WILLARD'S LEGACY

ITEM #4 - PRELIMINARY PLAT
WILLARD'S LEGACY

KPB File No.	2024-011
Plat Committee Meeting:	February 26, 2024
Applicant / Owner:	Trisha Jones and Lacy Cissney of Homer
Surveyor:	Katherine Kirsis / Seabright Survey + Design
General Location:	South Shore of Caribou Lake

STAFF REPORT

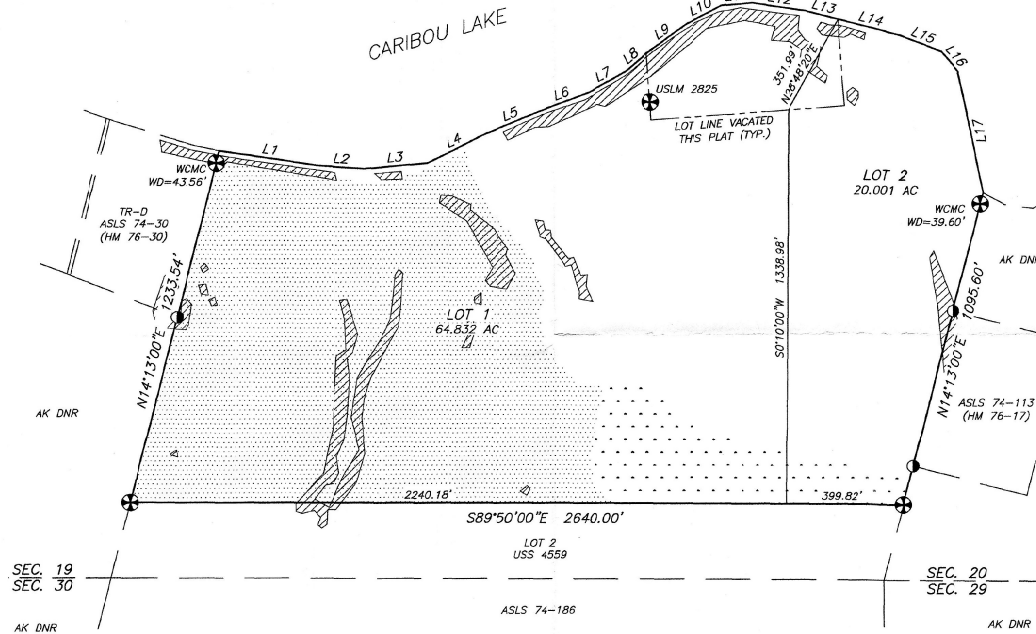
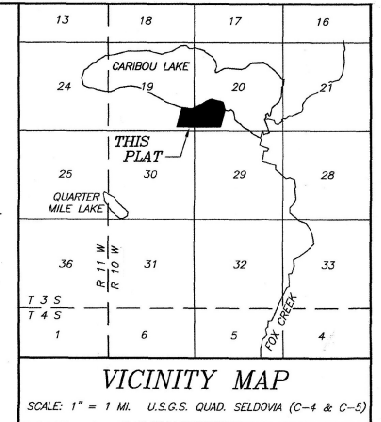
The plat is located in a remote location on Caribou Lake. No direct access is available to the plat. Small plane may be used to land on Caribou Lake and there are indications of trails to the structures on adjacent plats and aerial photos. Please note these on the plat. If the trails noted on adjacent surveys are still in use and are to be shown on the plat are private trails, **staff suggests** the following note be placed on the final plat to avoid confusion about public use in the future: 'Private trails shown are for use of owners only and are not dedicated to public use.'

There are steep areas on the plat as shown by the hatched boxes shown on the drawing. The steepest areas are located near the edge of the lake, as KPB contour mapping shows steepest spots near the structures.

Wetlands are indicated on the plat drawing with a designation of discharge slope and disturbed as identified from the KWF Wetlands Assessment, KPB GIS date. **Staff recommendation:** place a note on the final plat indicating any person developing the property is responsible for obtaining all required local, state, and federal permits, including a U.S. Army Corps of Engineers wetland determination if applicable.

Plat note 3 indicates the property to be in a FEMA FIRM mapped flood hazard area. KPB River Center did not indicate such designation, so note 3 can be removed. If the surveyor believes different, please contact the KPB River Center Flood Management desk.

Change KPB file no to 2024-011 in the title block

- Verification section line easements do not affect this subdivision should be done by surveyor on the land patent issued to George W. Willard.
 - There are trails shown on US Survey 4559, if these are still in use or existence, they should be located and shown.

- Show the approximate location of the section line between 19 & 20 on the drawing
 - Label land to the west as 'unsub'

- The borough will not enforce private covenants, easements, or deed restrictions per KPB 20.60.170.
- Plat note 3 is note necessary as the area was not designated as a flood hazard area district. If the surveyor believes the parcel to be in a flood hazard area, please contact the KPB River Center Floodplain Management.
- If the trails noted on adjacent surveys are still in use and are to be shown on the plat are private trails, **staff suggests** the following note be placed on the final plat to avoid confusion about public use in the future: Private trails shown are for use of owners only and are not dedicated to public use.

Add the date of February 26, 2024 to the Plat Approval note.
